LLFA COMMENT / QUERY TRACKER - 11.12.2019

Response to Further information request – 55 Fitzroy Park

SuDs CALCULATIONS	
Project: 55 FITZROY PARK	
GREENFIELD RUNOFF	
Sheet 1 of 8	
Project Reference: LBH 4599	
Date: 13/12/2019	Rev: 1
Client: Turner Stokes / Springer

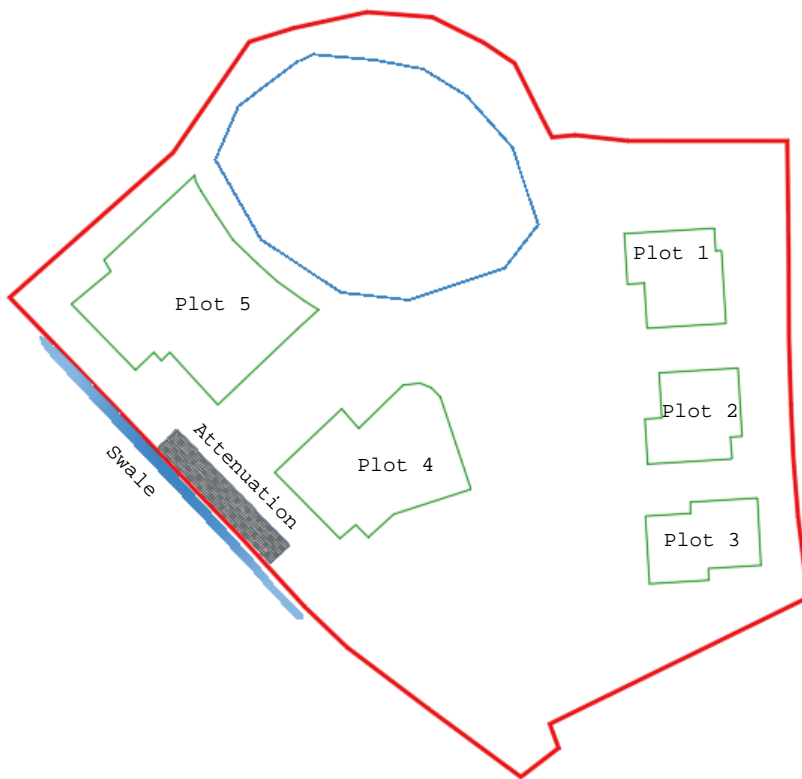
LLFA 2ND COMMENTS	APPLICANT RESPONSE	LLFA 3RD COMMENTS	LBH RESPONSE
<p>Plan shows:</p> <ul style="list-style-type: none"> 50 m³ surface water attenuation 15 m³ swale 3 m³ underground attenuation tank Flow controlled rate from driveway 5 l/s <p>Issue i: the indicated storage adds to 68 m³, a shortfall of 73.5 m³.</p> <p>Issue ii: No technical details indicated for the blue-green roofs (storage volume, area/depth, void %, flow controls, discharge rates etc.)</p> <p>Issue iii: no information on freeboard requirements</p>	<p>Issue i: There is a total storage volume of approximately of 141.5m³, which is made up as follows:</p> <ul style="list-style-type: none"> 15m³ in the swale 50m³ in the attenuation tank 76m³ in green and blue roof storage <p>Issue ii: The green/blue roofs will be designed by a specialist supplier/designer and it is unreasonable to request such details at this time as any specialist supplier/designer is unlikely to carry out a design without first receiving an order and deposit.</p> <p>Issue iii: The proposed house levels for the houses on the east side of the site are in excess of 1m above the level of Millfield Lane. From this it is clear there is more than ample freeboard provided.</p>	<p>Issue i: Noted. The blue-green roof storage information the Drainage Report. At least the Site Drainage Layout should be updated with the figures that make up the 76 m³. Further action requested</p> <p>Issue ii: Adequate information should be submitted at planning stage, based on outline designs generated by the drainage consultant. This is to show the LPA/LLFA how the proposed drainage measures, rates and volumes could be achieved in the scheme. Final detailed design information is not expected at this stage; it is accepted details may change, but the potential to achieve the stated aims should be demonstrated. Further action requested</p> <p>Issue iii: This request related to the SuDS freeboards as per original comment: "Provide the maximum volume each of the SuDS features can accommodate, as well as freeboard requirements in order to verify if the 141.5 m³ of attenuation required can be accommodated and indicate the discharge rate from the impermeable driveway to the combined sewer. Further action requested</p>	<p>Issue i: <i>The roof designs will be undertaken by a specialist designer in due course.</i></p> <p><i>At this stage a conservative assumption might be made as follows:</i></p> <p><i>Assumed Approx. green/blue roof area</i></p> <p><i>Plots 1 to 3 - 80 m² each</i> <i>Plots 4 & 5 - 135 m² each</i> <i>Assumed equivalent depth water retained 150mm</i> <i>(3 x 80) + (2 x 135) = 510 m²</i> <i>510 m² x .15m = 76.5 m³</i></p> <p><i>NB. Coyle Kennedy have provided a further assessment (attached) based upon revised areas that suggests 125m³ of blue/green roof storage to be potentially available.</i></p> <p>Issue ii: <i>Coyle Kennedy have provided additional information (attached) to demonstrate how the drainage measures will be achieved.</i></p> <p>Issue iii: <i>Coyle Kennedy have indicated a surplus storage capacity of some 50m³. Given that there is no potential for freeboard within the filled swale and the attenuation tank this can be accommodated within the roof designs as a freeboard of some 60mm. (see attached CK detail)</i></p>

There is a total storage volume of approximately of 141.5m³, which is made up as follows:

Make up of attenuation volumes:

Swale 46m x 1.0m effective deptg filled with stone (33% voids) = 15m³
attenuation tank – 18 x 3 x 95% voids = 50m³

Blue and Green roof

Plot 1 - 101m² of roof by 150mm deep = 15.2m³
Plot 2 - 98m² of roof by 150mm deep = 14.7m³
Plot 3 - 95m² of roof by 150mm deep = 14.3m³
Plot 4 - 214m² of roof by 150mm deep = 32.1m³
Plot 5 - 329m² of roof by 150mm deep = 49.4m³

Total = 190 m³

In relation to the storage volume there is a freeboard of 50m³.

Blue and Green roof Process

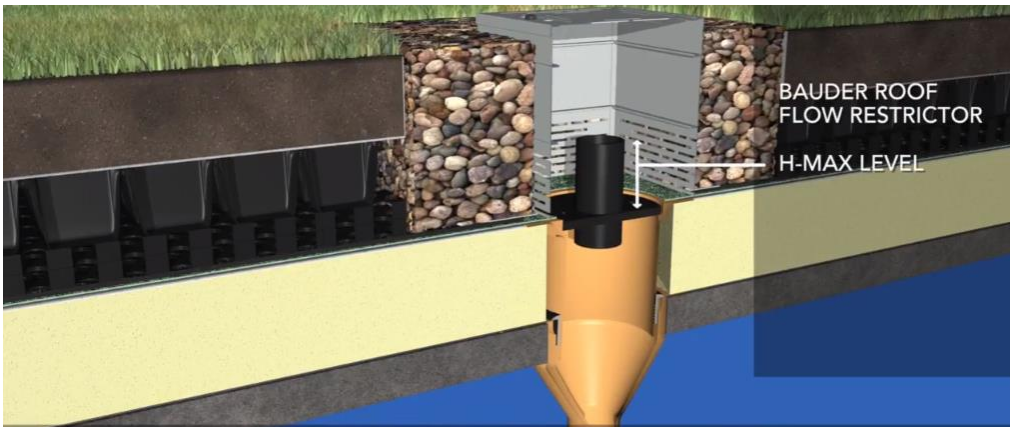
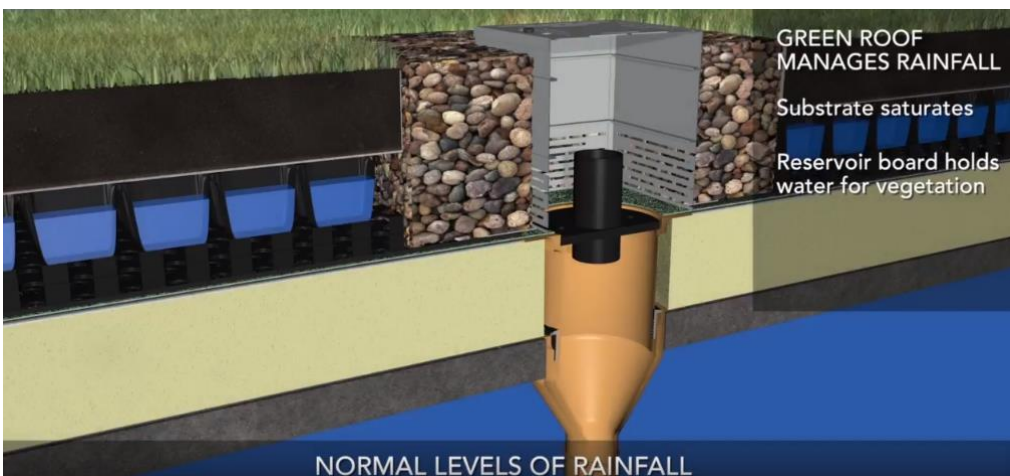
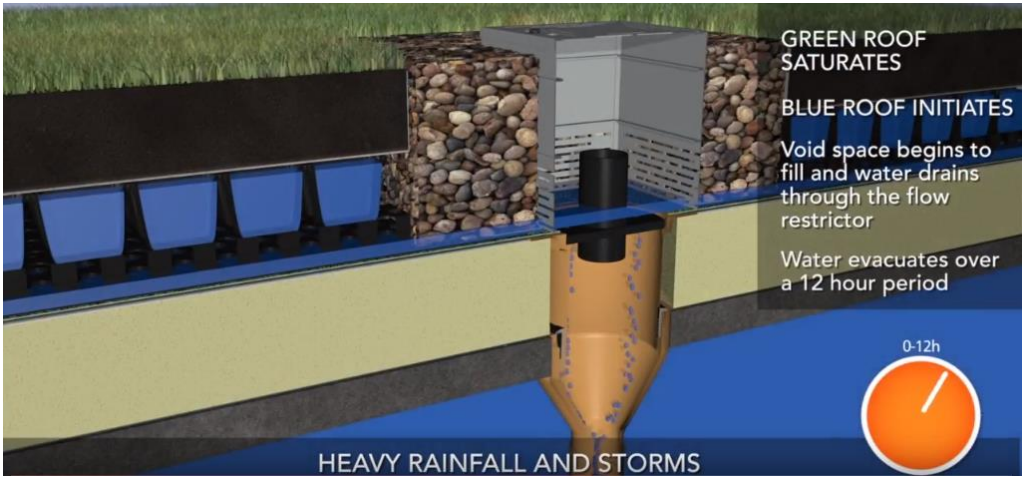
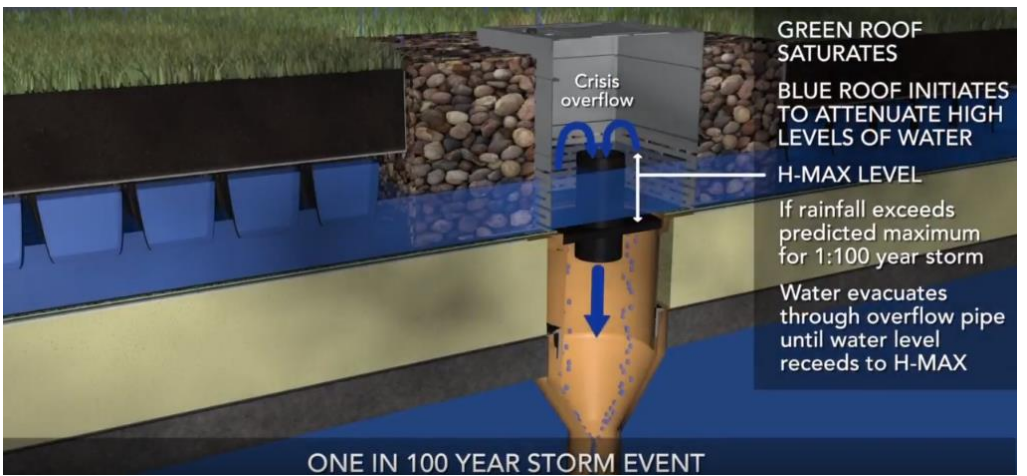
Issue ii

Normal levels of rainfall – substrate saturates, reservoir holds water for vegetation – no discharge

Heavy rainfall – water overflows the storage cells into the void space and drains through the flow restrictor attenuating the discharge

1:100 year event – if the rainfall exceeds the maximum 1:100 rainfall event the excess rainfall discharges the via the overflow pipe at high level – the remainder of the water is attenuated as normal.

Landscaping detail – typical detail shown adjacent to plot 5

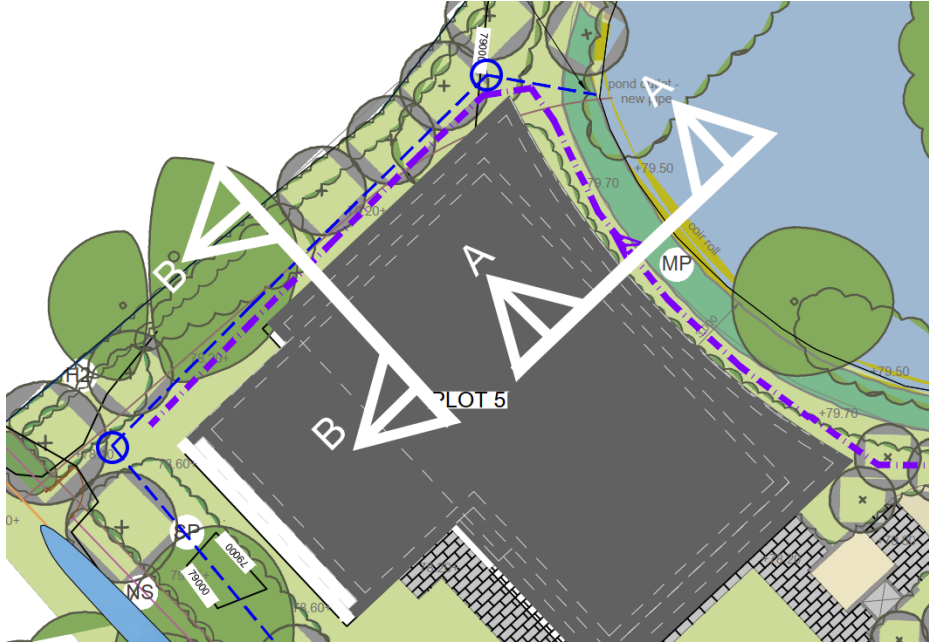
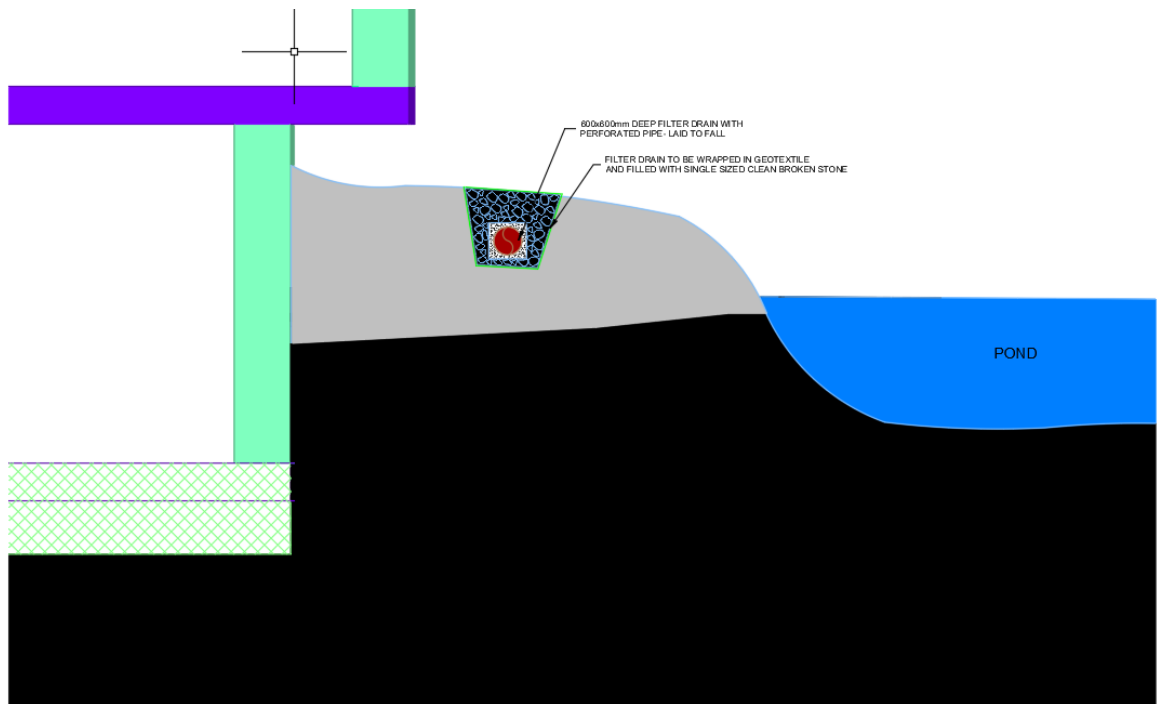
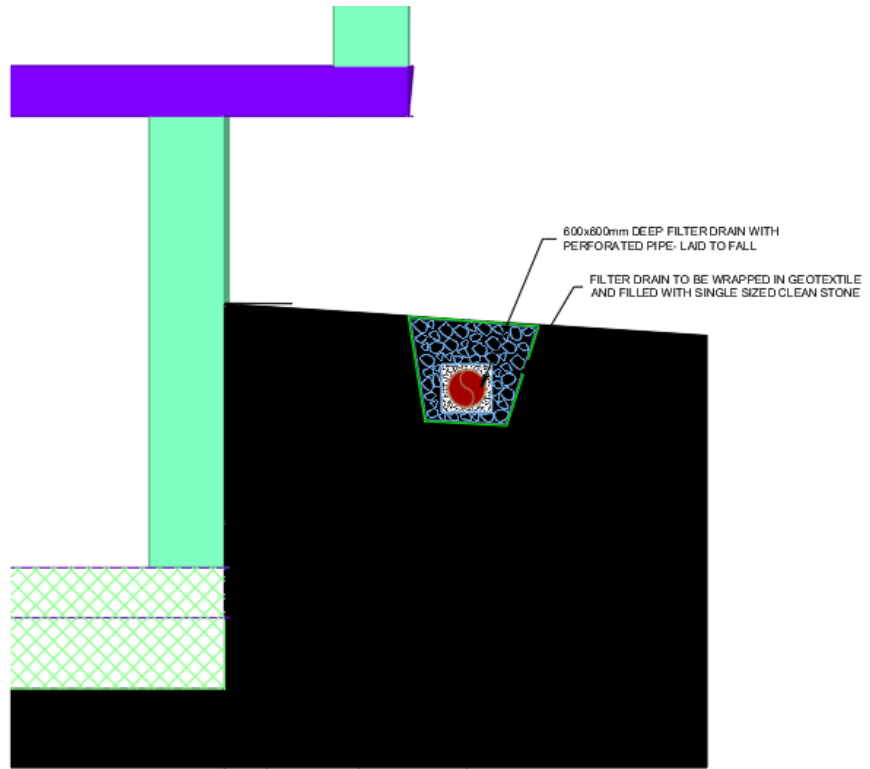
LLFA COMMENT / QUERY TRACKER			
LLFA 2ND COMMENTS	APPLICANT RESPONSE	LLFA 3RD COMMENTS	LBH RESPONSE
<p>The reference states landscaping without providing further details.</p> <p>Issue vi: Final details may be conditioned, but we should ask for additional information to clarify the measures in outline.</p>	<p><i>[Not addressed in 'Response to Further information request – 55 Fitzroy Park']</i></p>	<p>Further action requested</p>	<p>Issue vi:</p> <p><i>The landscaping details will be finalised in due course to provide the flood defence required. The required measures were outlined in the Hydrological & Hydrogeological assessment LBH4480 Ver 2.0 section 7.8 (page 31), where it was indicated that local landscaping would be used to direct any surface water flooding away from Plots 4& 5 and direct this to the designated overland flood route immediately to the north of Plot 5. (see attached additional information in the form of a plan and sketch sections by Coyle Kennedy)</i></p>

The details below show the intent of the landscaping/drainage adjacent to divert the water away from the buildings to the attenuation/swale area.
